**RE: Final Status Survey – Background Count Rate Correction
University of Michigan – Ford Nuclear Reactor
Docket 50-2 / License R-28**

Ameriphysics LLC.
Final Status Survey Data Sheet
Beta Survey Results

Building: FNR Survey Unit: SOLL-2 Page 4 of 26

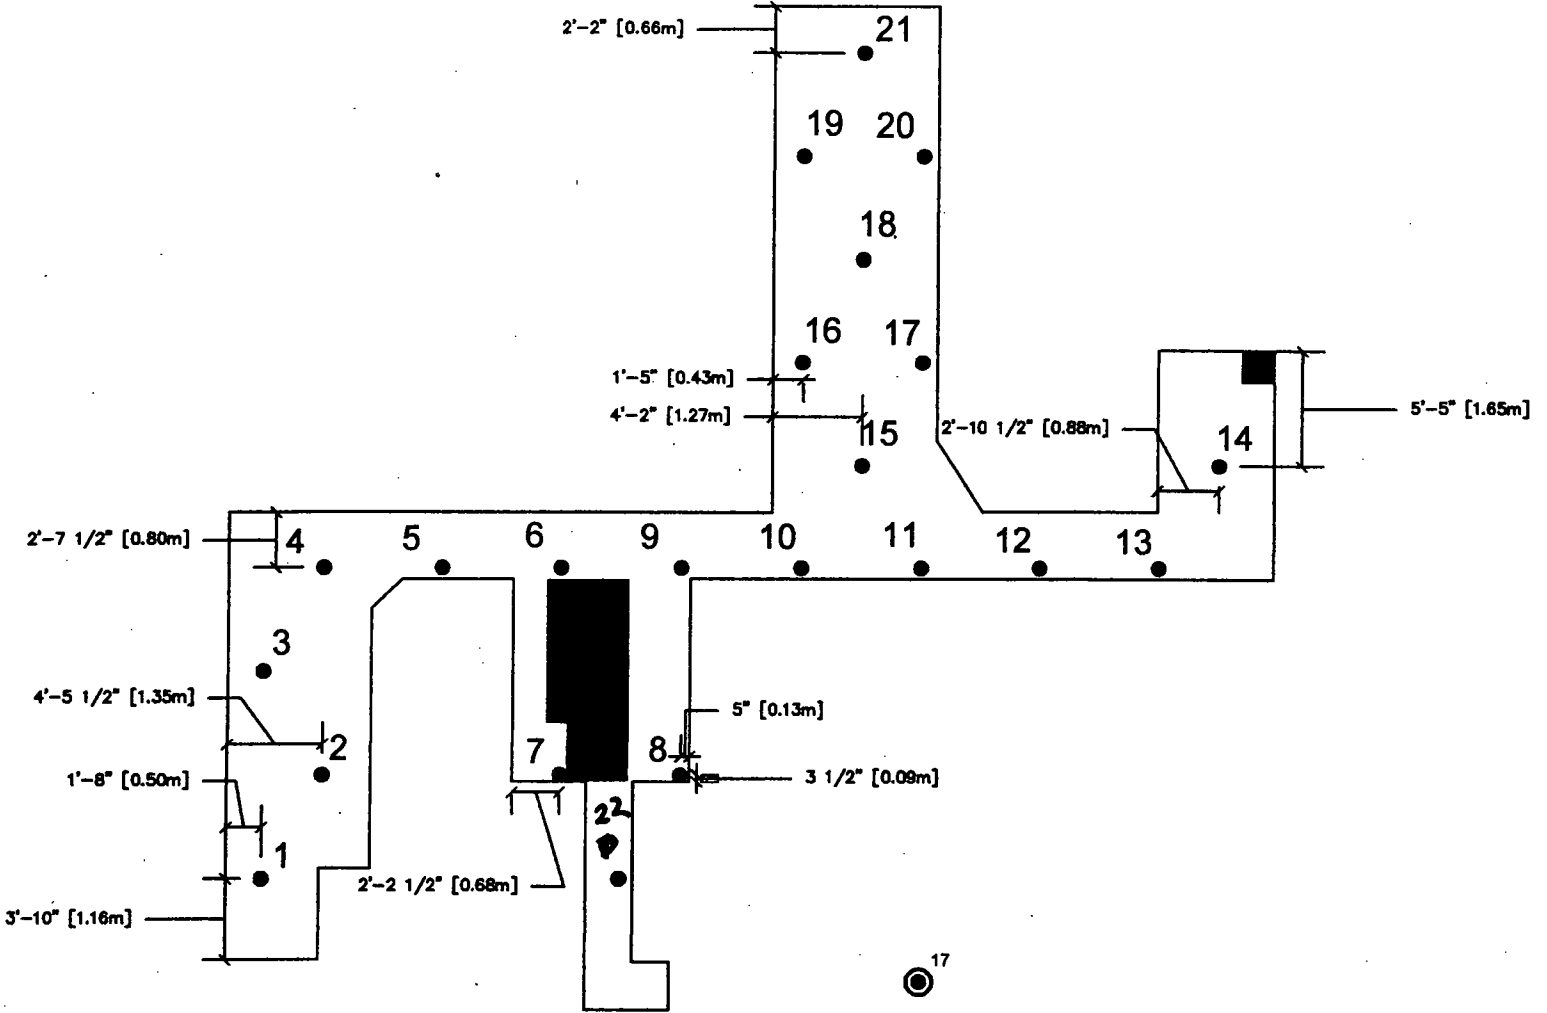
The correct background count rate (cpm) for the Ludlum Model 44-10 gamma scintillation detector (S/N PR194988) used on December 6, 2012 was 10259 cpm. Please refer to the corrected Final Status Survey Data Sheet enclosed with this correspondence.

Inst. #1	Inst Type: <u>Ludlum 2221</u>	Inst. S/N: <u>202370</u>	Cal Due Date: <u>9-24-13</u>	Count Time: <u>0.25M/SEC.</u>	BKG (cpm): <u>10259</u> 10466
	Probe Type: <u>44-10</u>	Probe S/N: <u>PR194988</u>	Inst Eff: <u>N/A</u>

MTO
08/15/13
~~MTO~~
08/15/13
